Access Compliance Report

Public Rights-of-Way

(Curb Ramps)

Intersection ID: 15439	Main Street: TROTTERS RIDGE RD	Cross Street: JEWELFLOWER RD	Location: SW
ADA ID: B8F2CEB02B8E	Ramp Type: PerpDiag	Initial Pass/Fail: Fail	Overall Compliance: No
Severity Score: 33.75			
Codes/Mitigation Info/Possible Solution		Field Measurements/Component Compliance

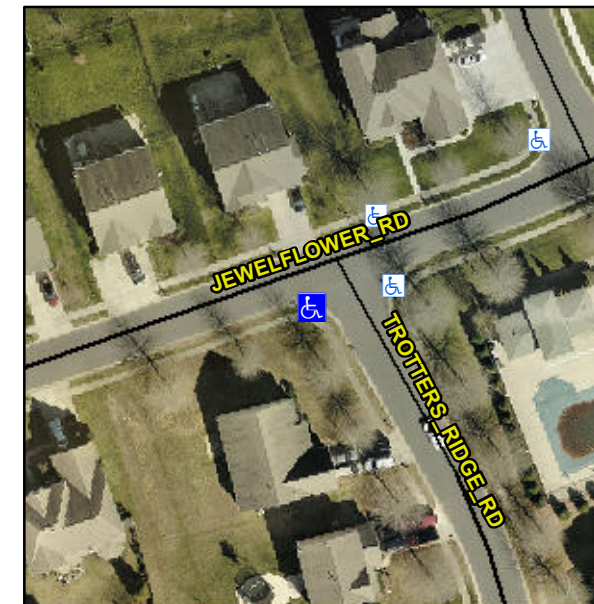
R304.5.1, R304.2.2, R304.5.3

Compliance	Description	Data	Compliance	Description	Data
N/A	Ramp Length (in)	49.0	No	Ramp Slope (%)	9.2
No	Ramp Width (in)	47.0	No	Ramp XSlope (%)	5.1
N/A	Flare Type LT	N/A	N/A	Flare Type RT	N/A
N/A	Flare Slope LT (%)	N/A	N/A	Flare Slope RT (%)	N/A
N/A	Flare Traversable LT?	N/A	N/A	Flare Traversable RT?	N/A
N/A	Landing Length (in)	N/A	N/A	DWS Provided?	N/A
N/A	Landing Width (in)	N/A	N/A	DWS Contrast?	N/A
N/A	Landing Slope (%)	N/A	N/A	DWS Length (in)	N/A
N/A	Landing X Slope (%)	N/A	N/A	DWS Full Width?	N/A
N/A	Landing Curb? (Y/N)	N/A	N/A	DWS Offset (in)	N/A
N/A	Shared Landing?	N/A			
N/A	Gutter Ponding?	N/A	N/A	Gutter Slope (%)	N/A
N/A	Gutter Lip Ht (in)	N/A	N/A	Gutter X Slope (%)	N/A
N/A	Painted X Walk1?	No	N/A	Painted X Walk2?	No
	X Walk 1 Direction	To E		X Walk 2 Direction	To N
N/A	X Walk 1 Width (in)	N/A	N/A	X Walk 2 Width (in)	N/A
	X Walk 1 Slope (%)	2.7		X Walk 2 Slope (%)	2.1
	X Walk 1 X Slope (%)	2.2		X Walk 2 X Slope (%)	5.2

Remove & Replace Curb Ramp With Two New Directional Ramps or Equivalent.
